CHANGE ORDER #14
INSTRUCTION BULLETIN
DEFERRED APPROVAL
PROJECT NAME

CHILDREN'S HOSPITAL
OF ORANGE COUNTY

TOWER II

LEVEL 3
REFLECTED CEILING PLAN
AREA - C

A4.3C

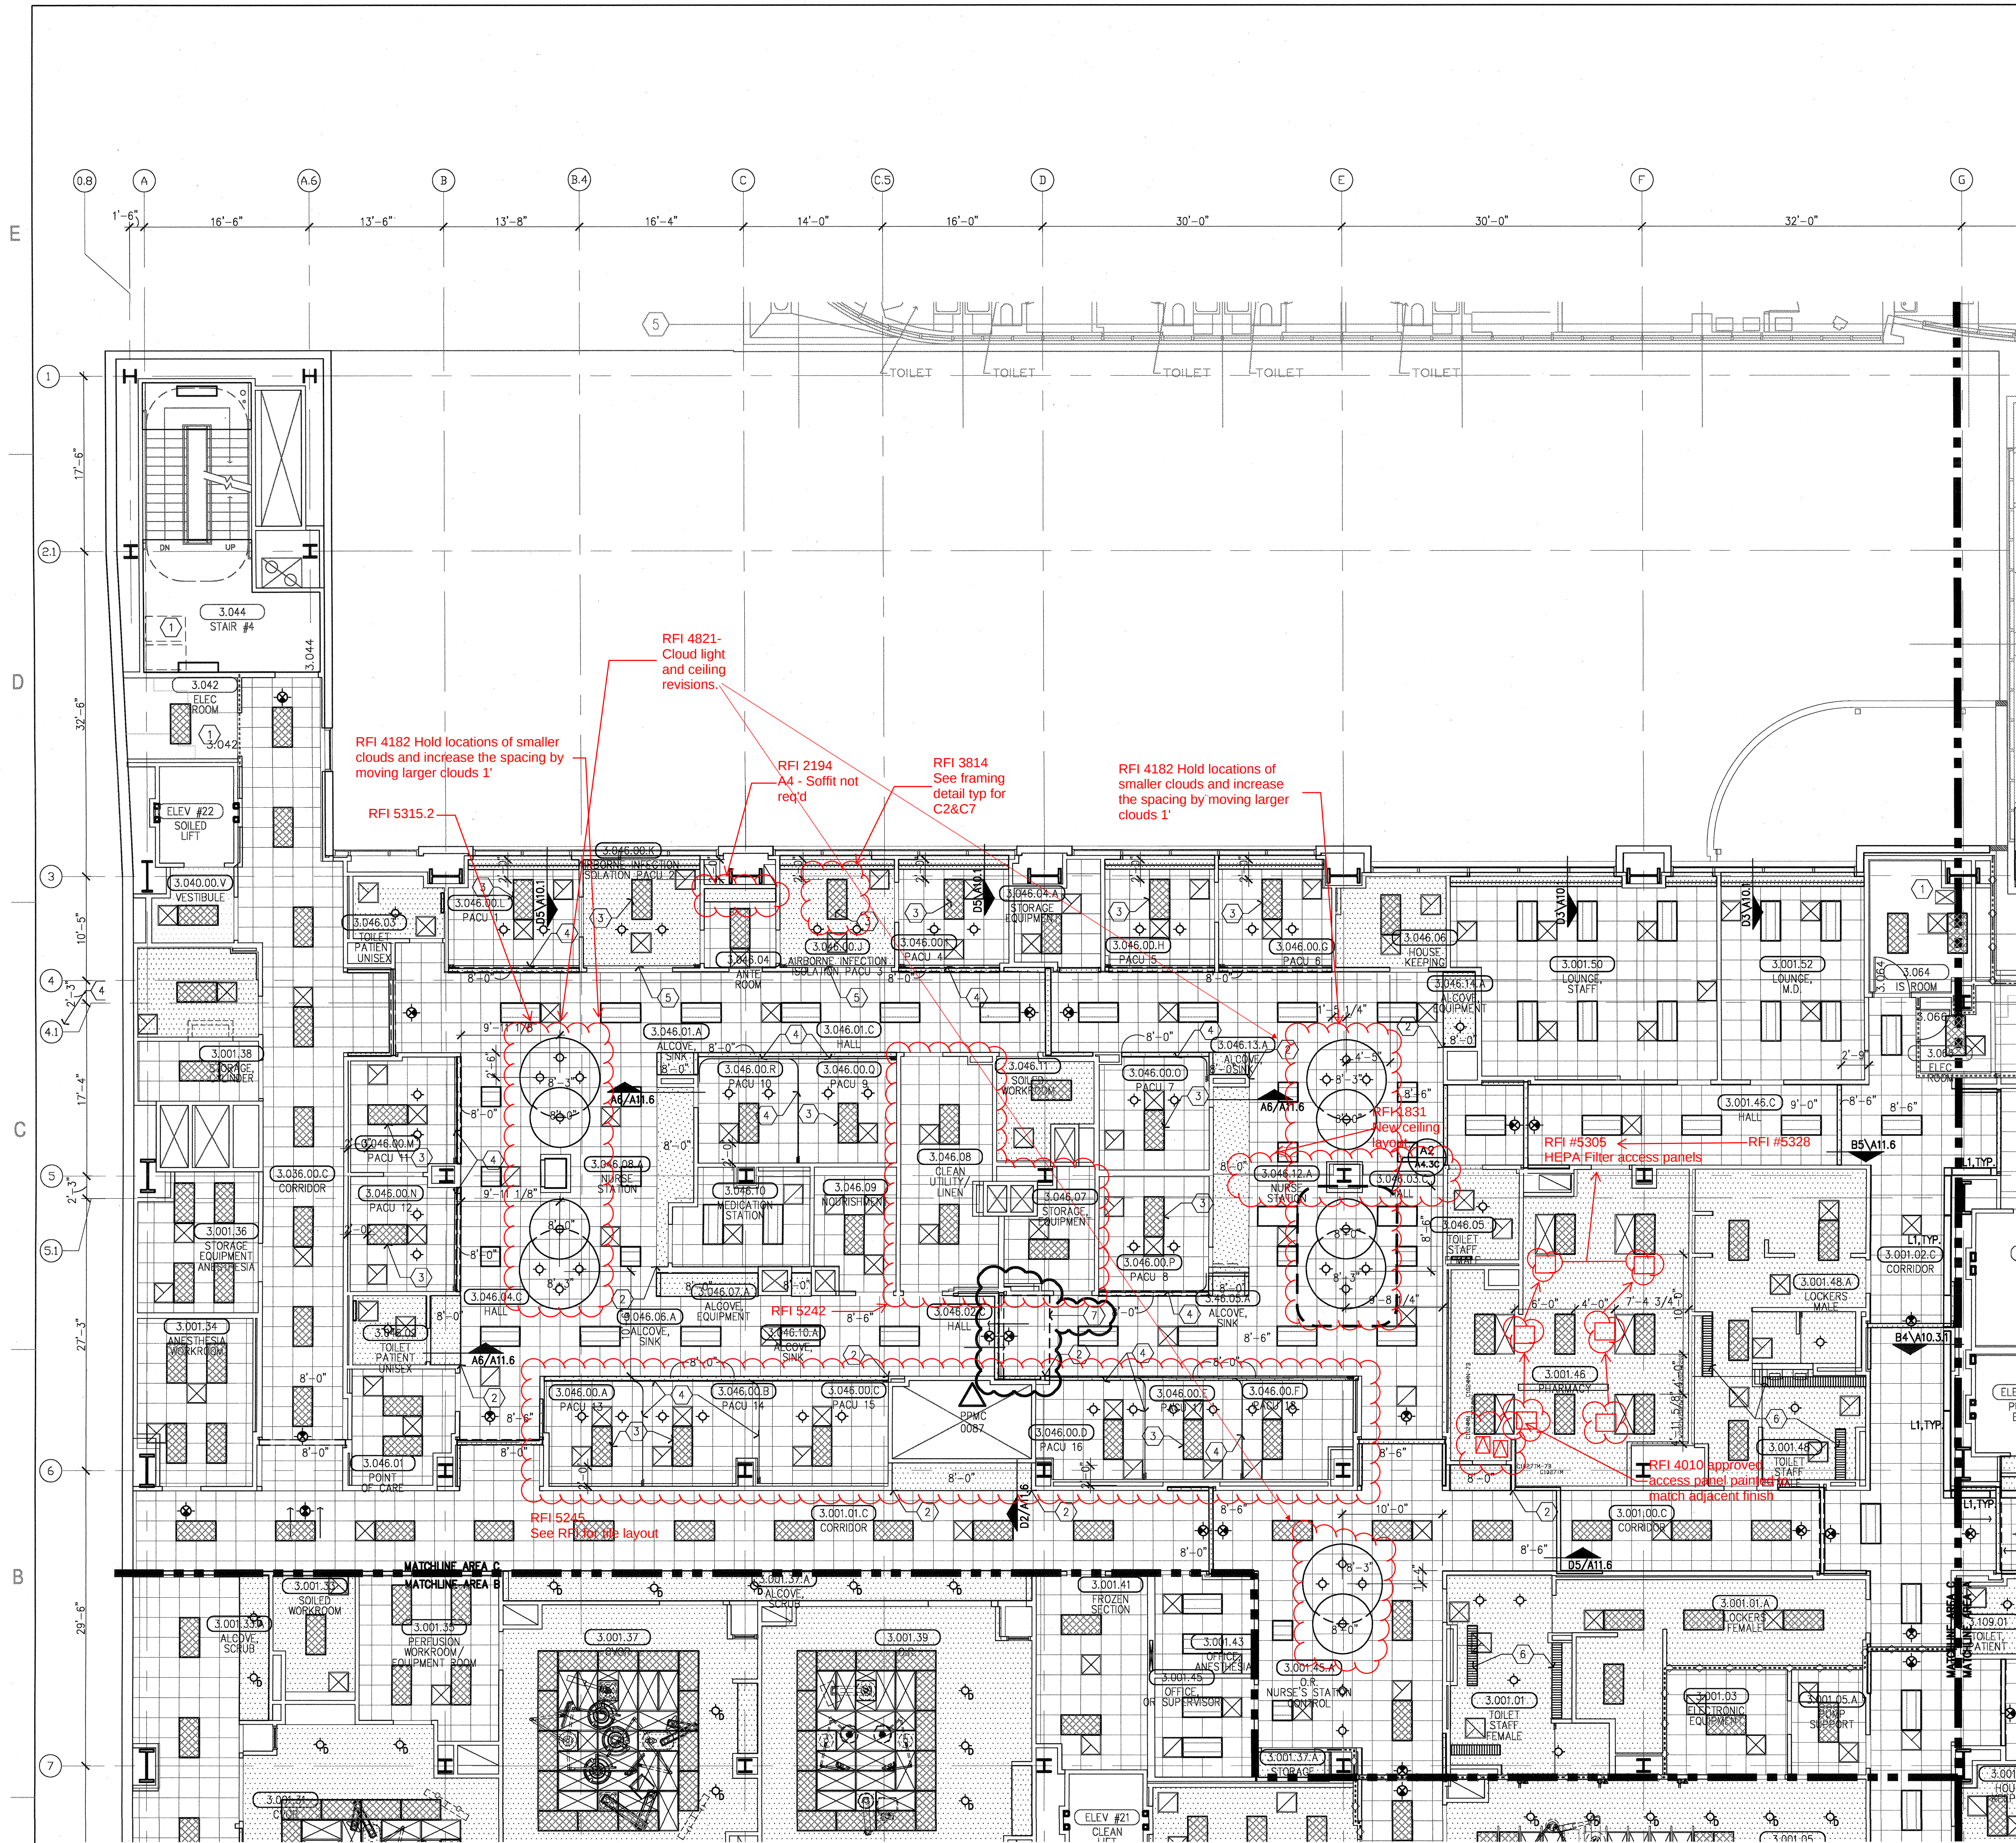
RFI #5471
3rd floor RCP
coordination.

RFI #4587
Revised RCP's for Level 3
access panel locations.
